ADDENDUM NO. 1

**ARCADIA HIGH SCHOOL
LOCKER ROOM ALTERATION
ARCADIA UNIFIED SCHOOL DISTRICT**

tBP/ARCHITECTURE
4611 Teller Avenue
Newport Beach, CA 92660
949-673-0300

This Addendum forms a part of the Contract Documents and modifies the original Bidding Drawings dated August 15, 2024, and Specifications dated July 2024. Acknowledge receipt of this Addendum in space provided on the Bid Form. Failure to acknowledge may subject Bidder to disqualification.

A4-1

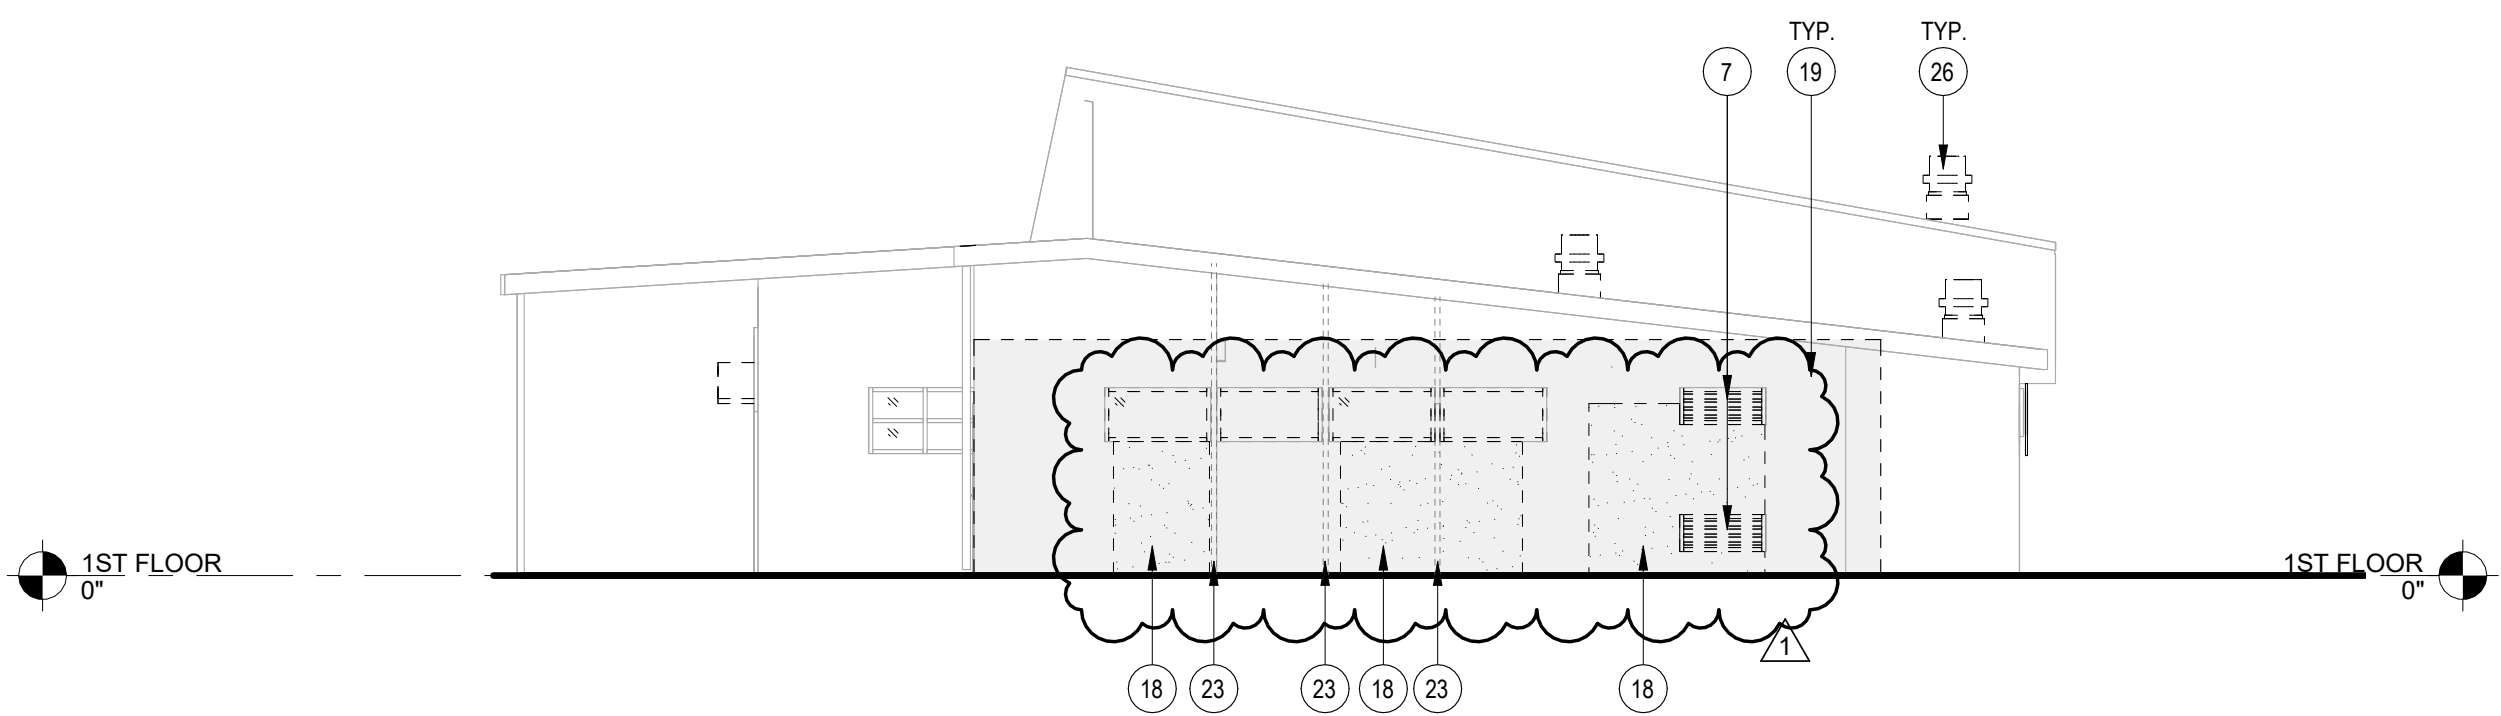
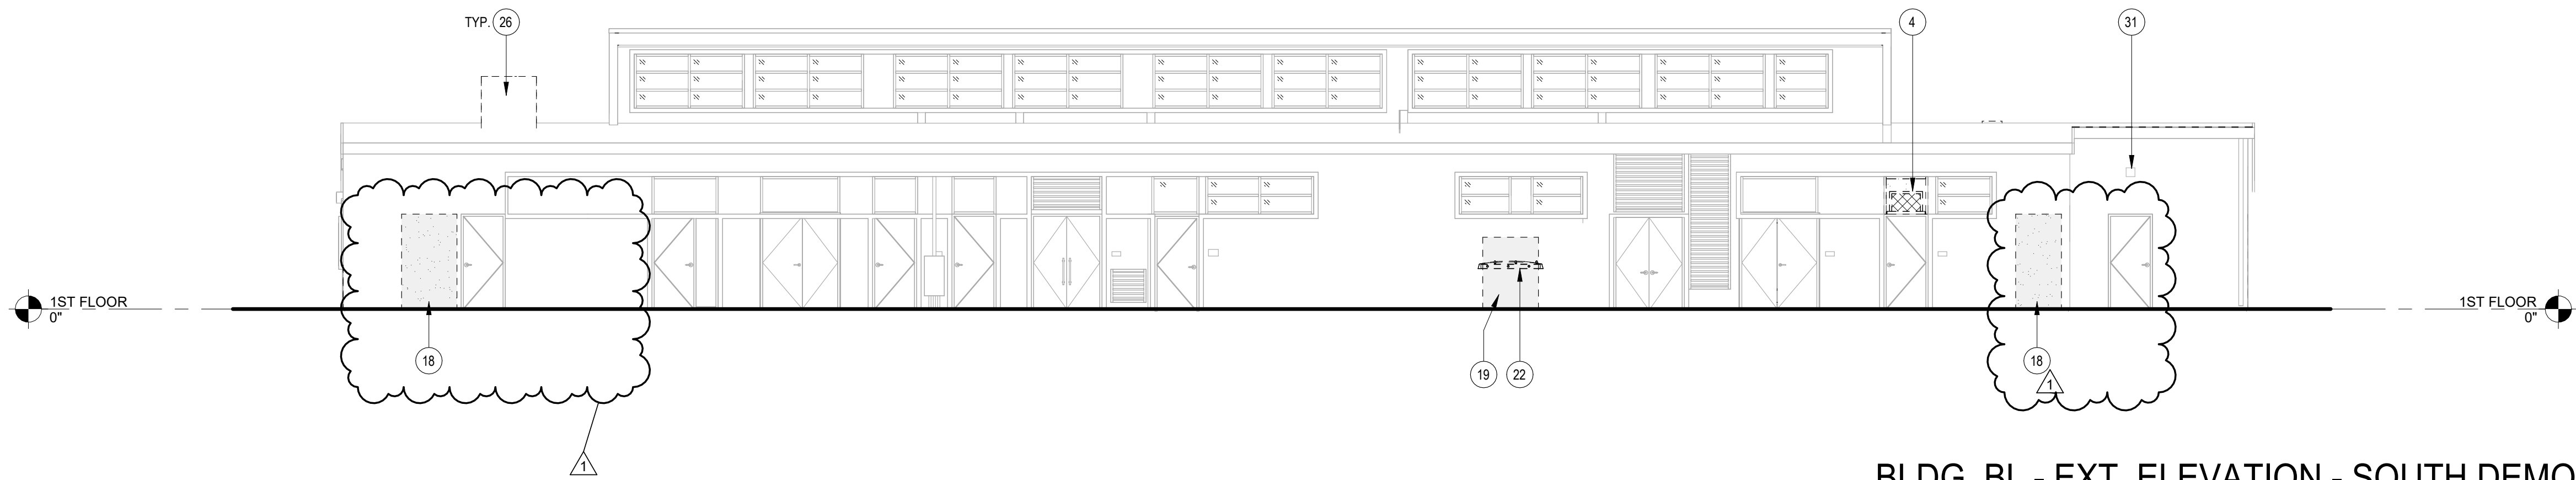
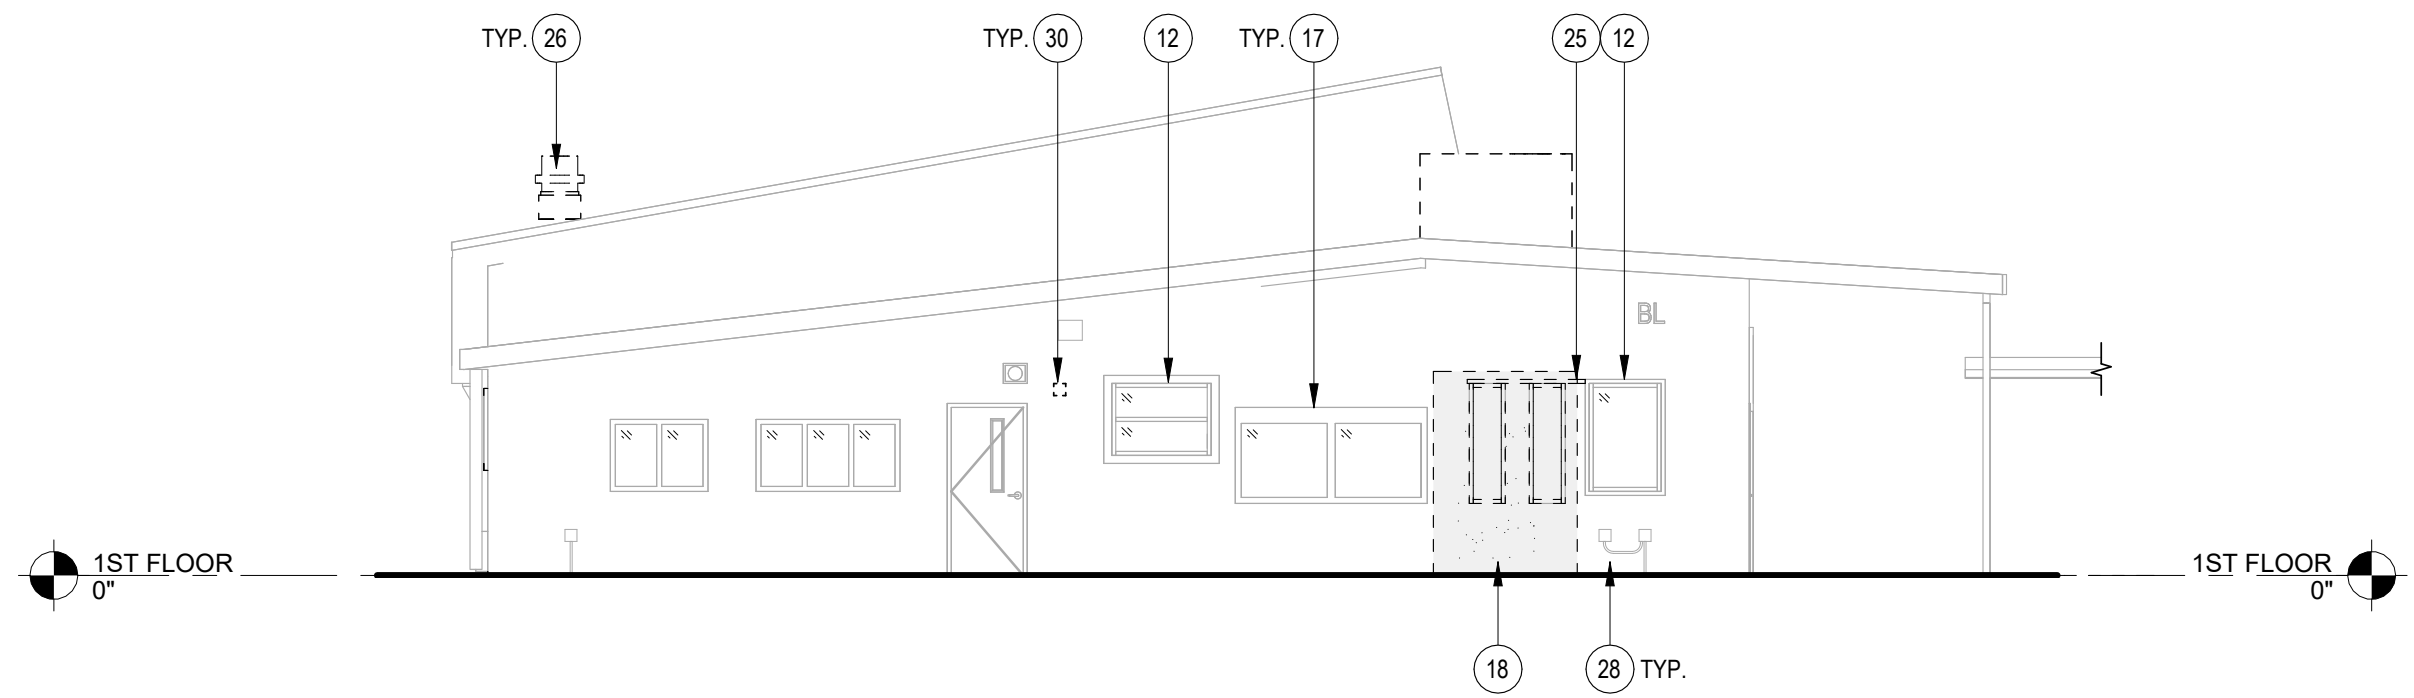
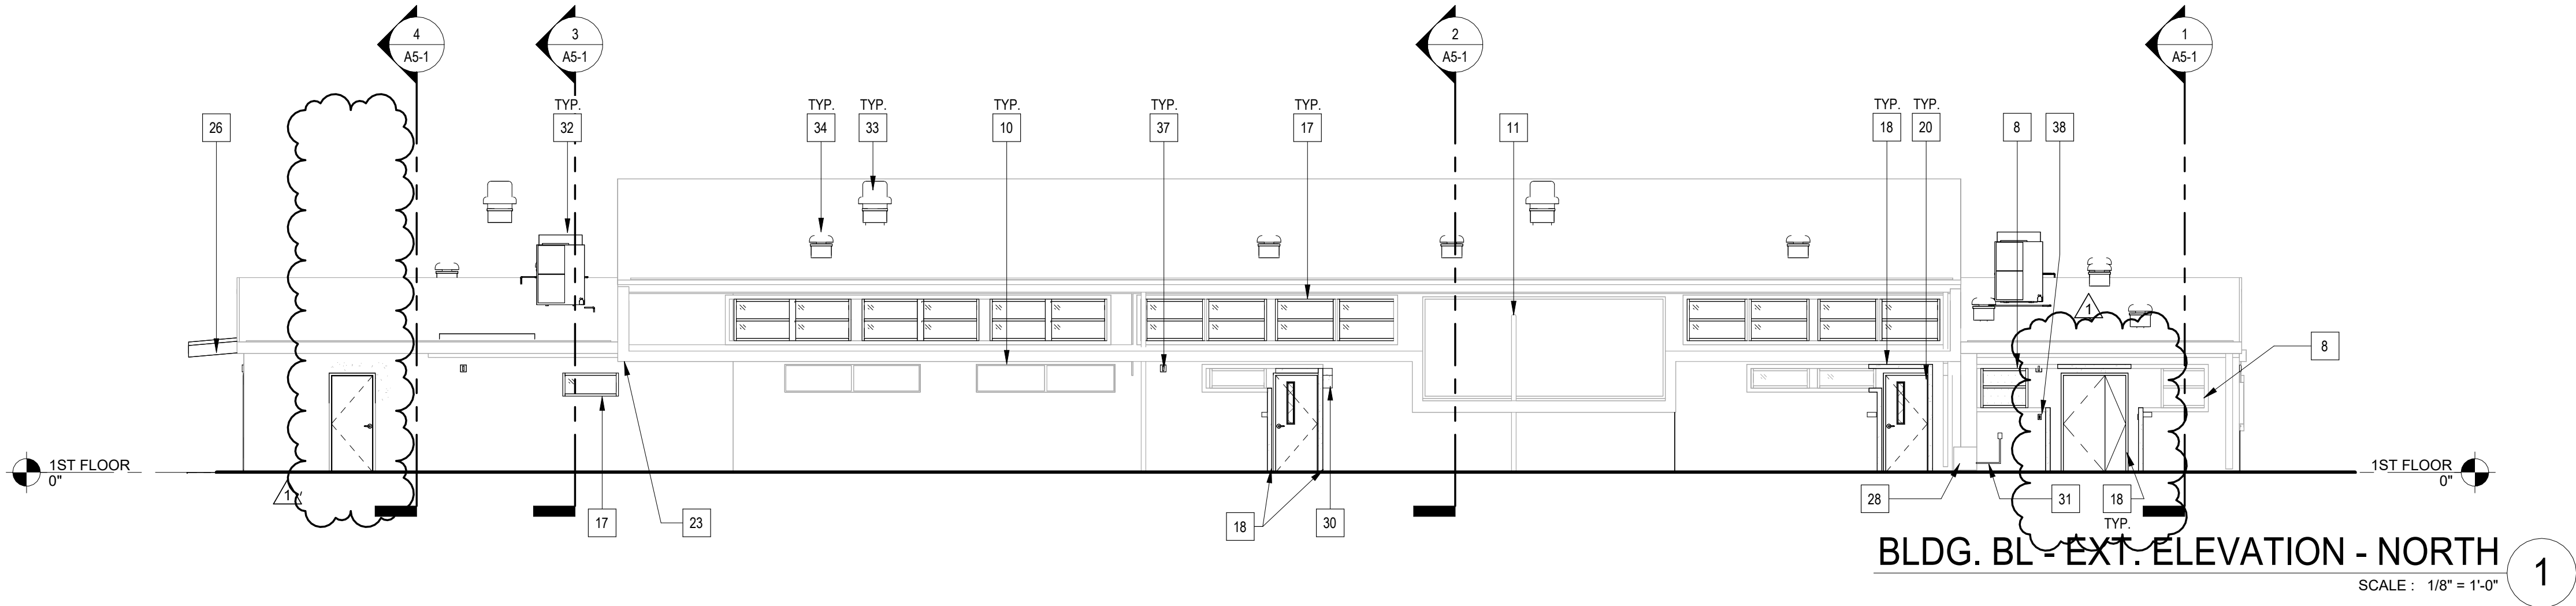
- a. Add exhaust fans on roof in accordance with mechanical plan.
10. SHEET A4-1 – BUILDING BL – DEMOLITION EXTERIOR ELEVATIONS
Replace full size sheet drawing **A4-1** in its entirety, issued with this addendum.
Changes include:

- a. Remove portion of exterior walls, louver and its frame in accordance with floor plan update.
11. SHEET A4-2 – BUILDING BL – REMODEL EXTERIOR ELEVATIONS
Replace full size sheet drawing **A4-2** in its entirety, issued with this addendum.
Changes include:
